Churchtown Road Upper: March 2022

1. Introduction

Fig 1. Illegal parking takes place inside cycle lane protection bollards

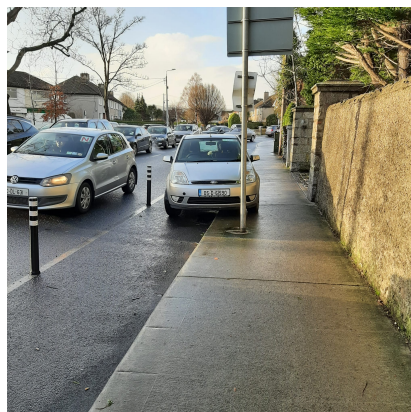
Parking on the footpaths and grass verges is a frequent problem along the proposed route. Hotspots include:

- at the east extent of the scheme, where delivery vans servicing businesses in 92-98 Churchtown Road Upper regularly park partially on the footpath
- west of Oakdown Road (south side)
- West of Landscape Road (northside)

The cycle paths should be protected from infringements at these points using bollards, planting, higher kerbing or other methods. At locations such as in front of 92-98, protection of the cycle path is needed, and sheffield stands on the edge of the footpath would also be useful in preventing drivers parking inside any cycle path protection.

Fig 3. Alternative route along Landscape Road.

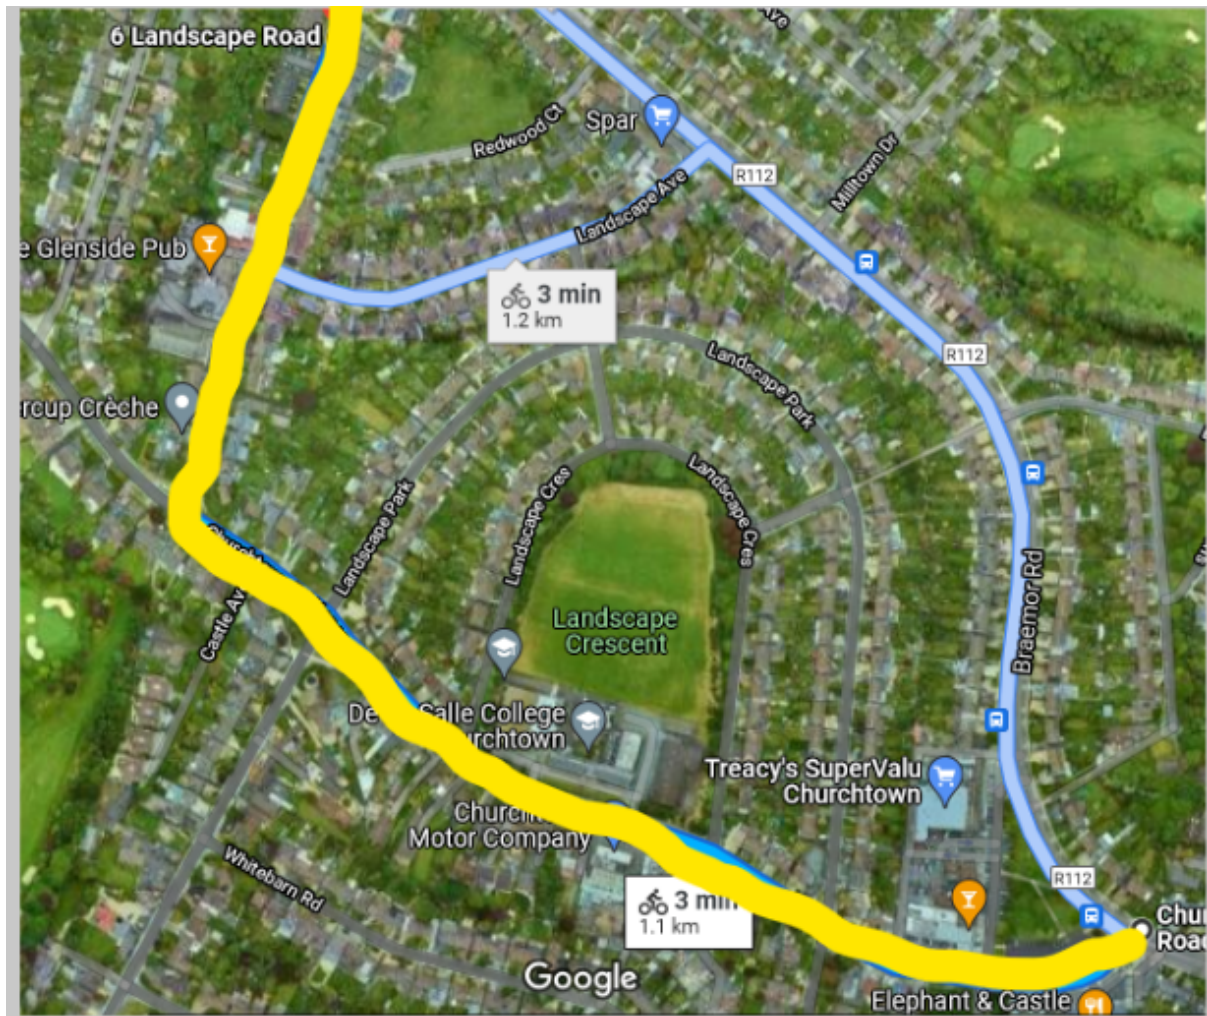
The western extent of the scheme is currently partially along Hillside Drive. It is unclear why the scheme should end here specifically. The road beyond Landscape Rd is primarily residential and traffic volumes there seem quite low. In contrast, Landscape Rd is a highly-used route, with amenities, shops and businesses (Buttercup creche, Fiacla Dental and Churchtown Expert Hardware, etc.). The scheme might be improved by routing down Landscape road to re-join Braemor Road in the North (Fig 2).
